Application Details	
Application Reference Number:	3/37/21/012
Application Type:	Full Application
Description	Outline application with all matters reserved, except for access, for the residential redevelopment of agricultural Land for up to 136 dwellings with the creation of vehicular access (closure of existing), provision of estate roads, pathway, public rights of way, cycleways and open recreational space. Also, partial re-alignment of public highway (Cleeve Hill) (Resubmission of 3/37/18/015)
Site Address:	Land At Cleeve Hill, Watchet, TA23 0BN
Parish:	Watchet
Conservation Area:	No
Somerset Levels and Moors RAMSAR Catchment area:	No
AONB:	No
Case Officer:	Simon Fox, Major Projects Officer (Planning) 07392 316159 s.fox@somersetwestandtaunton.gov.uk Should you wish to discuss the contents of this report item please use the contact details above by 5pm on the day before the meeting, or if no direct contact can be made please email: planning@somersetwestandtaunton.gov.uk

Agent:	Mr P Grubb, Lighthouse Development Consulting
Applicant:	Cleeve Hill Development
Reason for reporting application to Members:	In the public interest given the level of representations received in objection

Figure 5.1 – PIA data 2016 to 2020

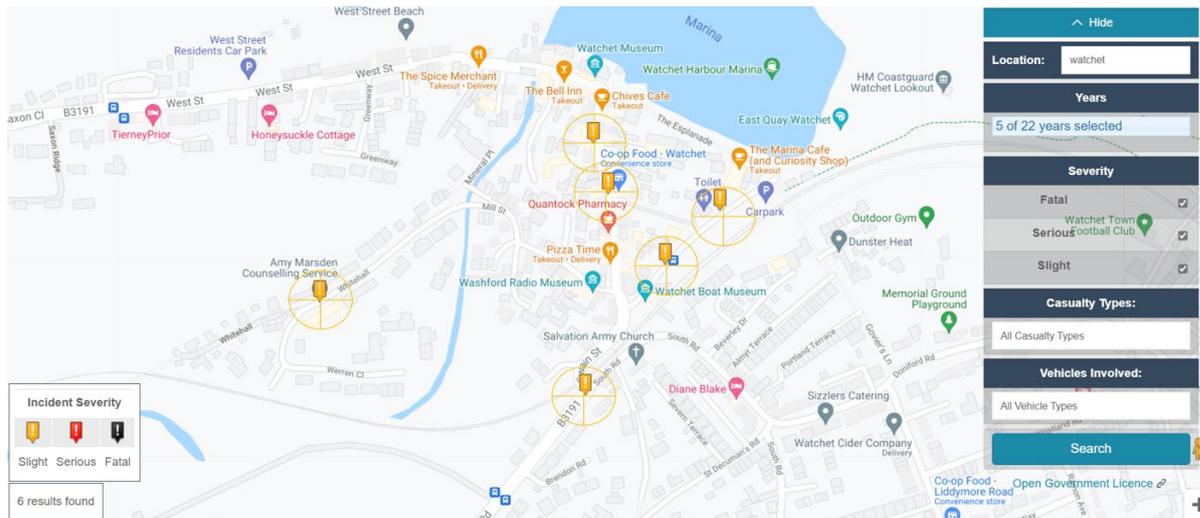
- 5.11. The proposed development will generate additional traffic in five of the six incident locations and will result in additional pedestrians and/or cyclists in all six. It should be noted that a Fatal PIA occurred on the B3191 in 2021 to the west of the development site but is not yet listed on the CrashMap website. The proposed development will also increase vehicle traffic in that location.

Figure 8.1 – Deficiencies in developer’s identified walking routes

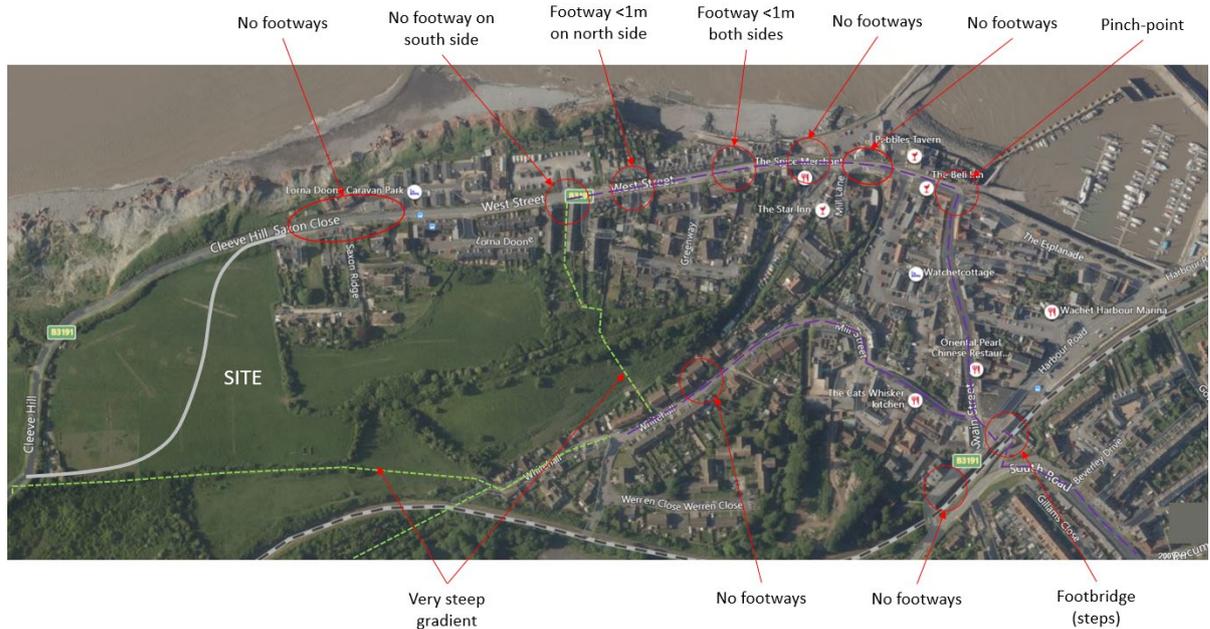
8.8. Figure 8.1 illustrates the significant deficiencies in the suggested walking and cycling routes on the submitted ‘Route to school NMU plan’. This is not intended to be a comprehensive study of the condition of walking and cycling provision as that responsibility falls to the developer; however, it is clear that the developer has still failed to demonstrate that safe and suitable provision can be made for pedestrians and cyclists in accordance with TR1 and TR2.

Plate 1 – Extract of Stantec (2020) Figure 2

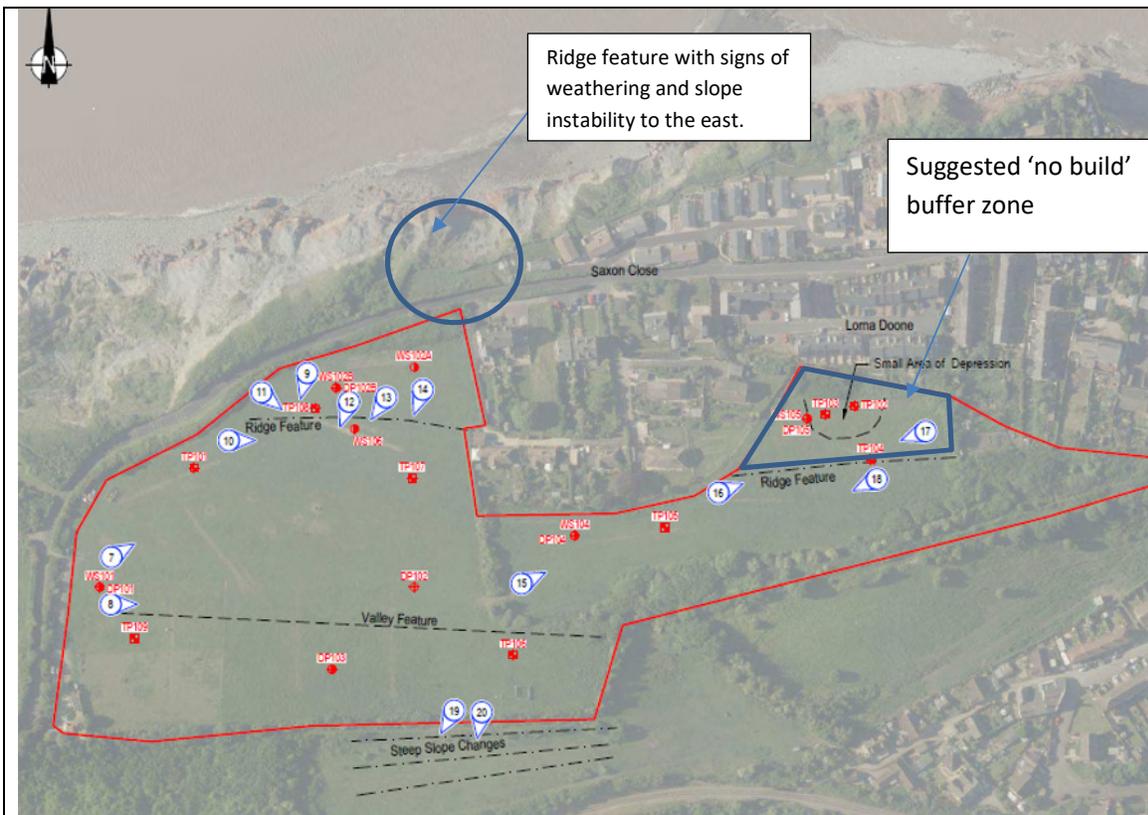
Also within this area, Stantec note a small arc with depression to the north of this ridge feature (Plate 1), to the south of Lorna Doone. The Stantec report states that the arc depression was investigated via two trial pits, which did not record any evidence to indicate that the ground is effected by ground movement

As such, no development should be permitted in this area. Fairhurst would therefore recommend if the planning application is granted permission, that a no build buffer zone is implemented beyond the geological ridge in this portion of the site, as indicated on Plate 1.
